## SERVICE BULLETIN

TITLE: FUSELAGE - BATTERY DRAIN MAST REMOVAL

This Service Bulletin is being issued to allow the removal of the P/N 95-410006-57 or P/N 002-400001-33 battery drain mast assembly provided no ADF (long-wire) antenna was anchored to the mast. This Service Bulletin allows the owner/operator the option of removing the mast assembly rather than replacing it in the event of any damage to the mast assembly.

**BATTERY DRAIN MAST REMOVAL**  
**FIGURE 1**

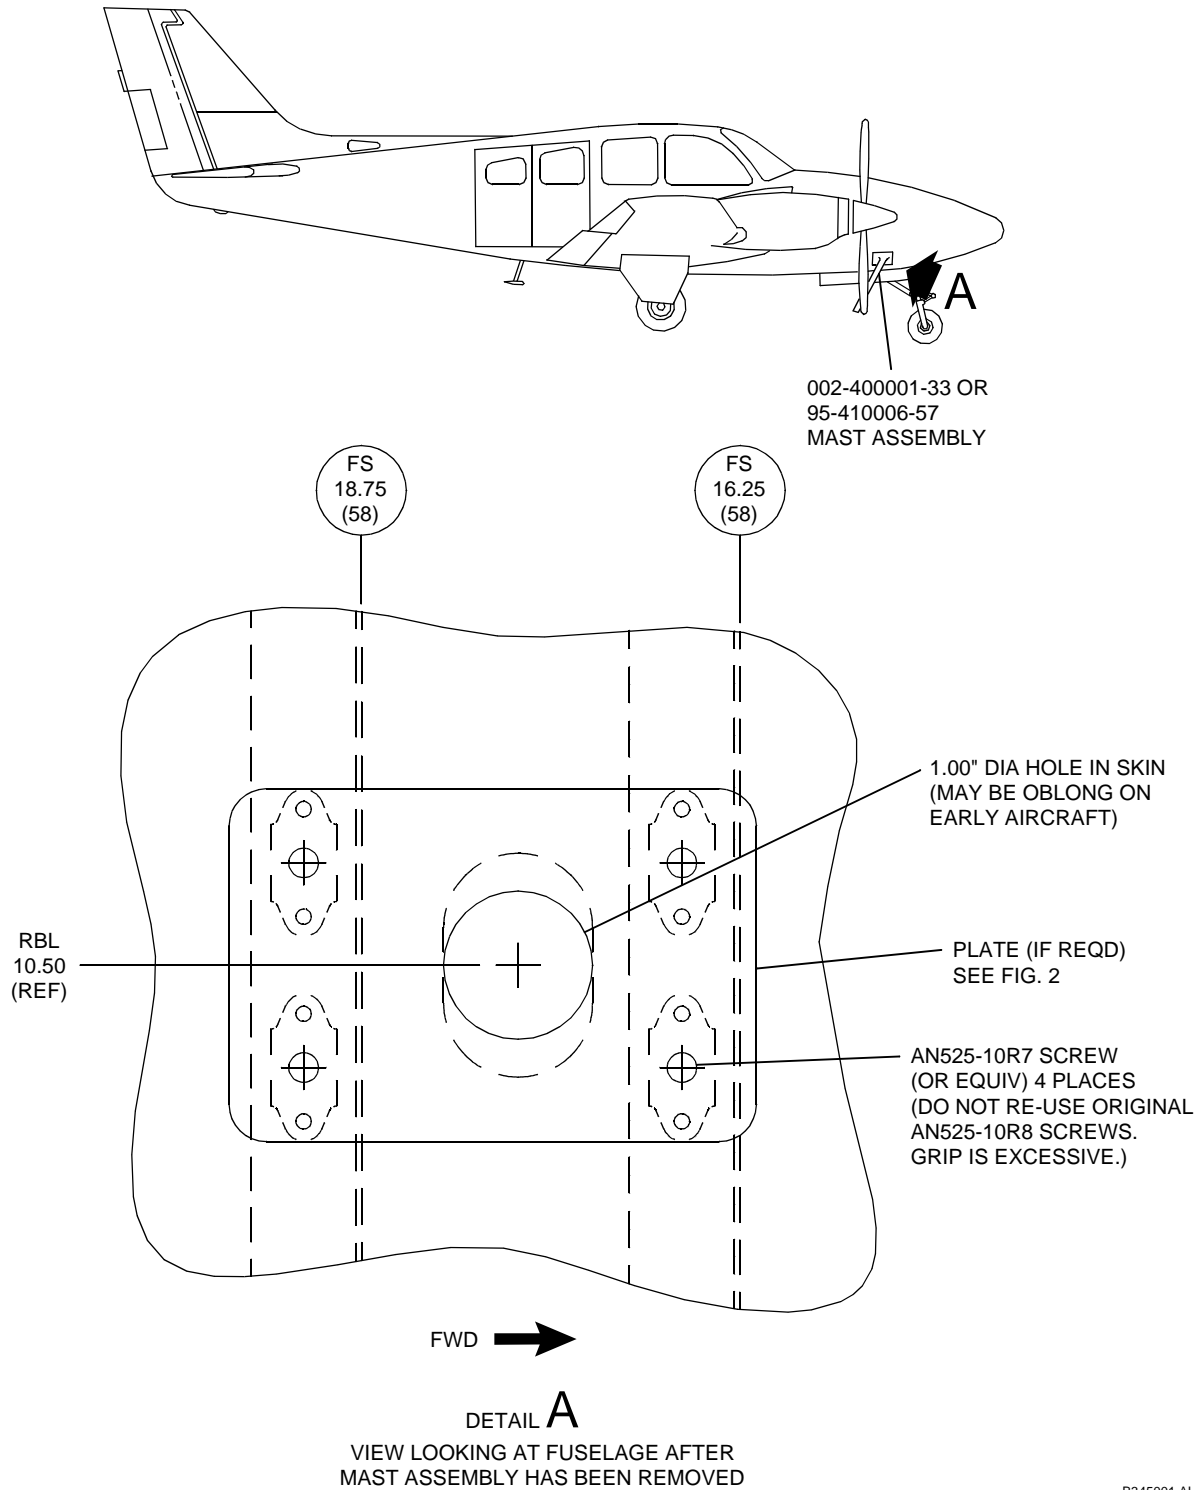
- (1) Remove all power from the airplane and disconnect the battery. Display warning notices prohibiting reconnection of airplane electrical power.
- (2) Remove the P/N 95-410006-57 or P/N 002-40001-33, mast assembly, by removing four AN525-10R8 screws that attach the mast to the fuselage. See figure 1.
- (3) Inspect the hole in the fuselage that the drain tube protrudes through. If the hole is round and approximately 1.00 inch diameter, proceed to step 9. If the hole is oblong or out of round, go to step (4). See figure 1.
- (4) Fabricate a plate made from .032 2024-T3 Alclad aluminum. Form to match skin contour. See figure 2.

- (8) Install the plate using four AN525-10R7 screws. See figure 1. Proceed to step 11.
- (9) Clean the area of the removed mast with cotton cheesecloth or clean wiping rag dampened with appropriate solvent. Repeat solvent wipe cleaning, as necessary. Wipe surfaces dry with clean cotton cheesecloth. Paint to match surrounding paint scheme.

**BATTERY DRAIN MAST REMOVAL  
FIGURE 2**

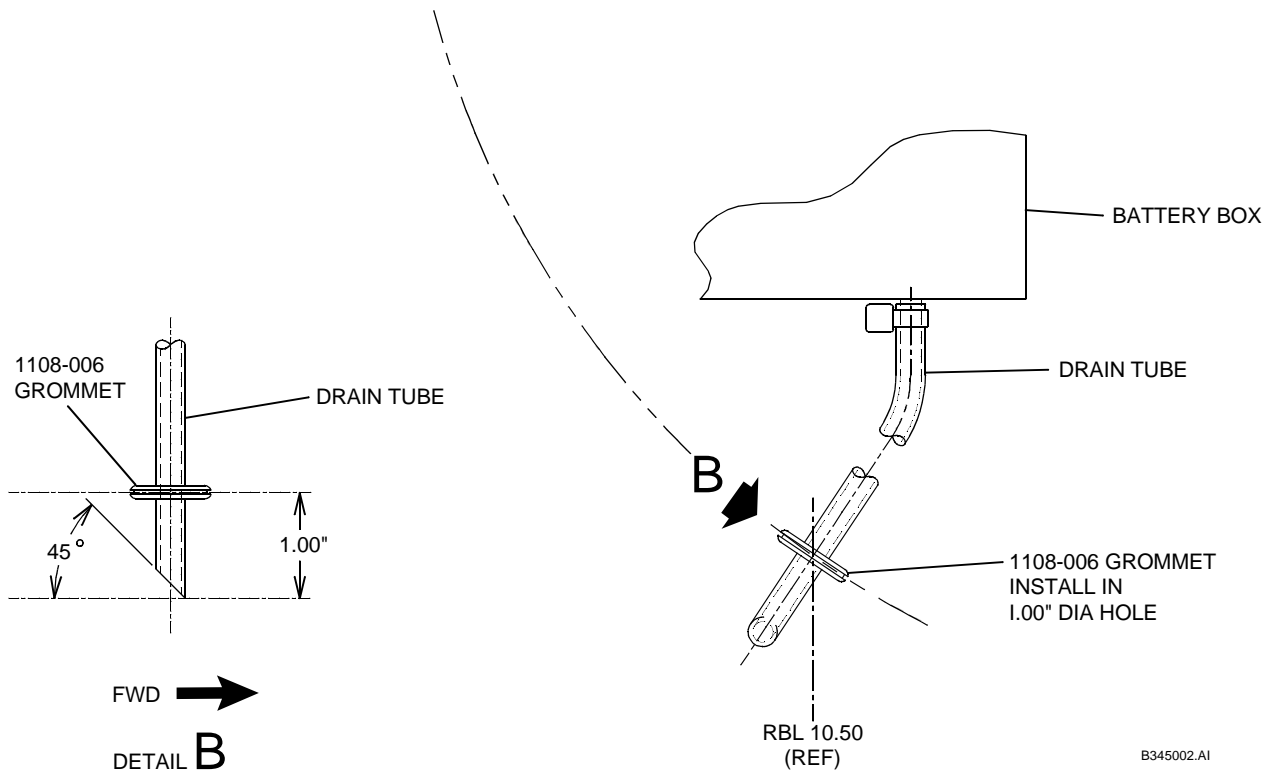
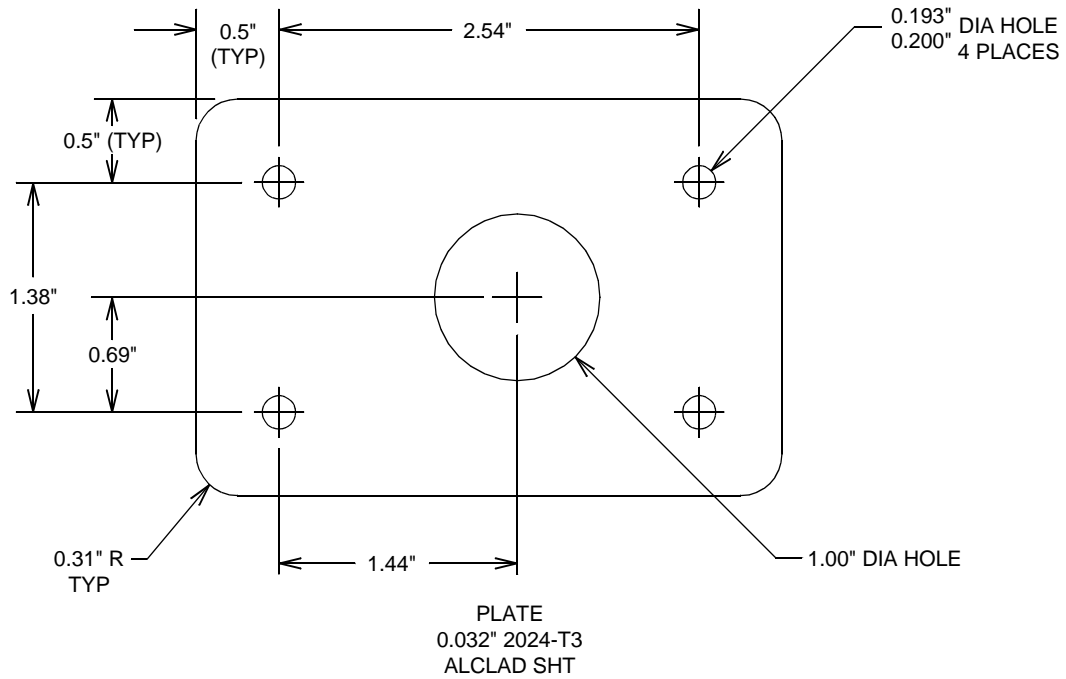
- (10) Install four AN525-10R7 screws to fill open nutplate holes.
- (11) Install the battery drain hose through the center of the grommet. Install the P/N 1108-006 grommet into the 1.00 inch diameter hole. See figure 2.

- (12) Cut the drain hose to match figure 2.
- (13) Reconnect the airplane battery, remove warning notices and restore power.
- (14) Ensure all work areas are clean and clear of tools and miscellaneous items of equipment.
